ACCESSIBILITY COMPLIANCE REPORT

For DA Application

Project Address: 45-45a Oaks Ave, Dee Why NSW

Report No: DA-24056

Att. 01 mackenzie architects international Floor Plans Issue. B Dated 23/05/2024

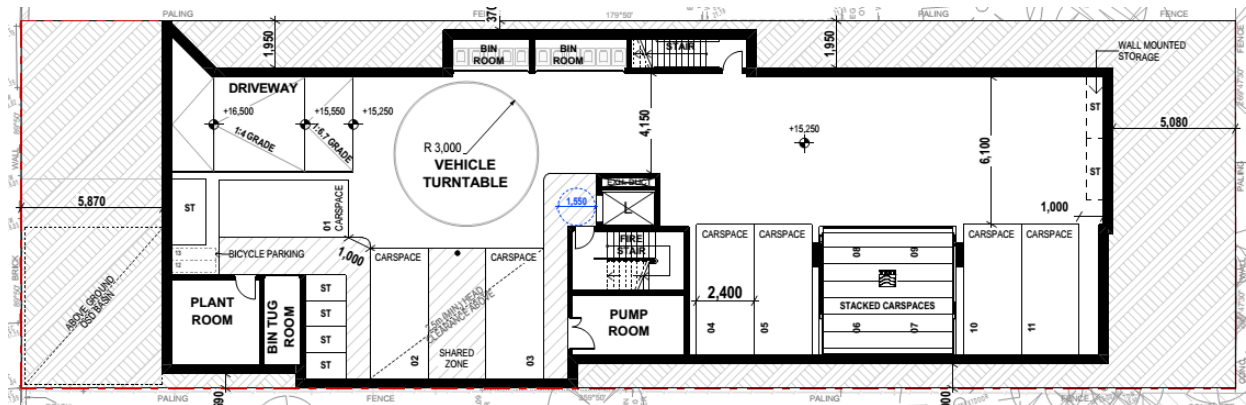
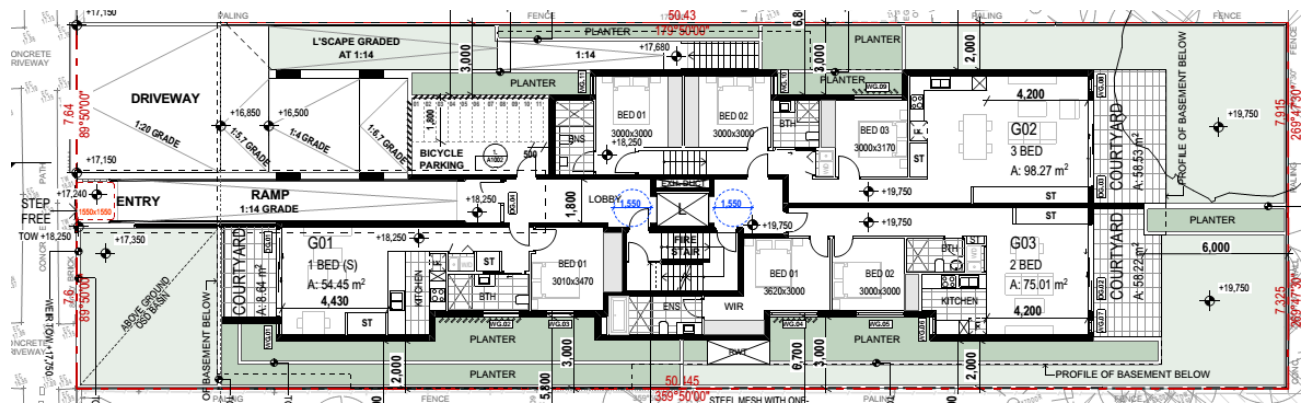
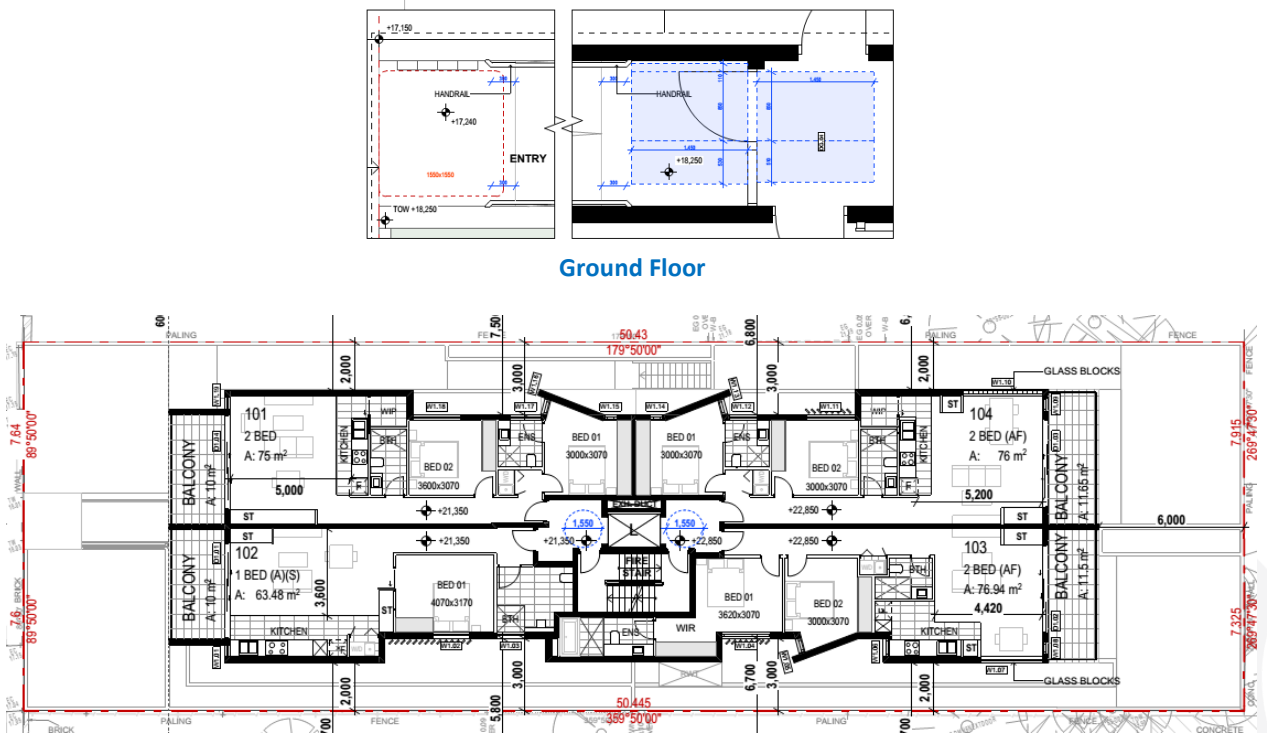
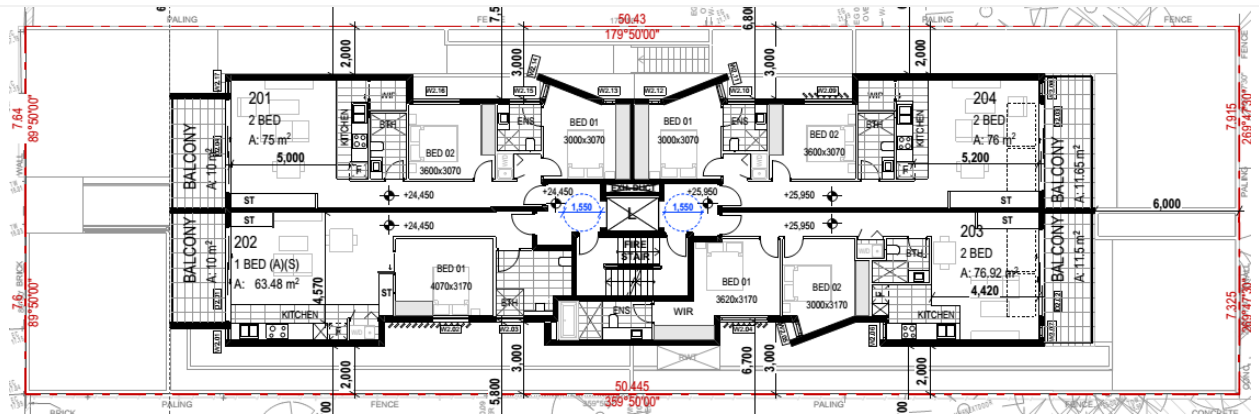
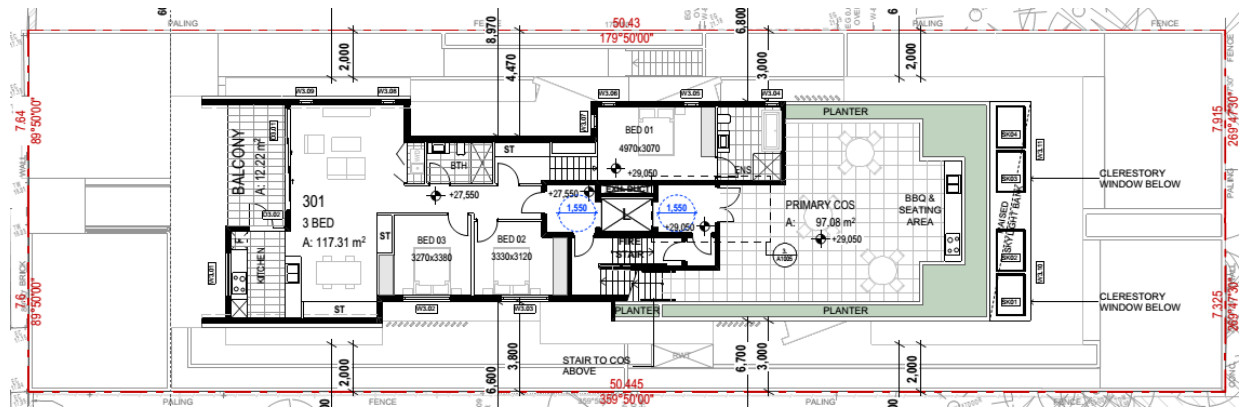
Notes: Capable of compliance at the CC stage – There are 2x Common Open Spaces Located on the third floor, the first one provides a step-free continuous accessible path of travel and the second one is accessible by means of stairs.

| The additional requirements set below to be read in full | ADR | N/A | C |
|--|--|--|-------------|
| <p>1. Access ways:</p> <ul style="list-style-type: none"> All access ways must have a minimum width of 1m clear and a vertical clearance of at least 2m. <p>Reference: Figure 24, Figure 25 Notes: See Att.01 – capable of compliance at CC stage</p> | <input type="checkbox"/> | <input type="checkbox"/> | ✓ |

Post Adaptable units 102 & 202

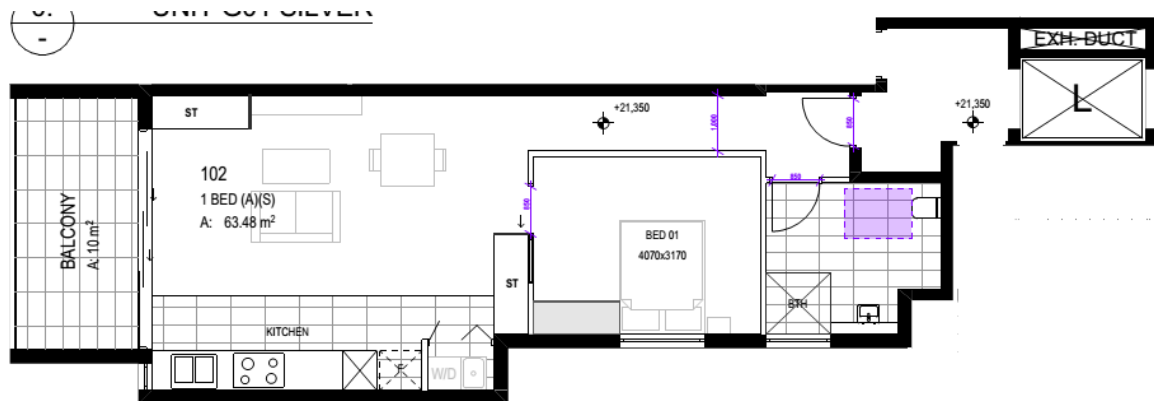
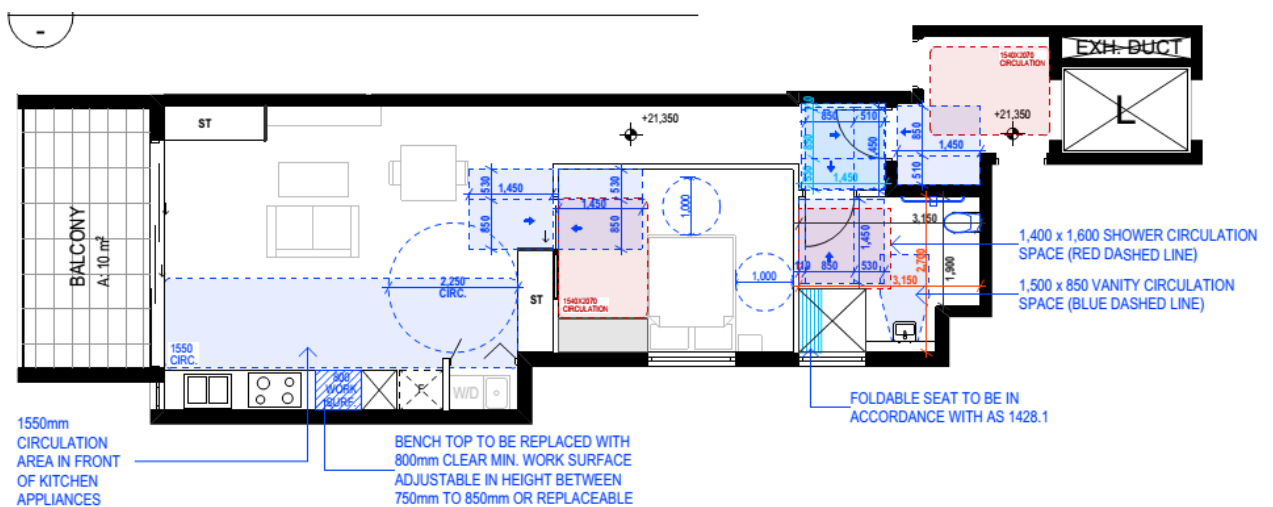
| D4D6 Accessible car parking | ADR | N/A | C |
|--|--------------------------|--------------------------|--------------------------|
| Notes: The proposed development has a total of "12" units, therefore, a total of "2" Adaptable units is required and have been provided | | | |
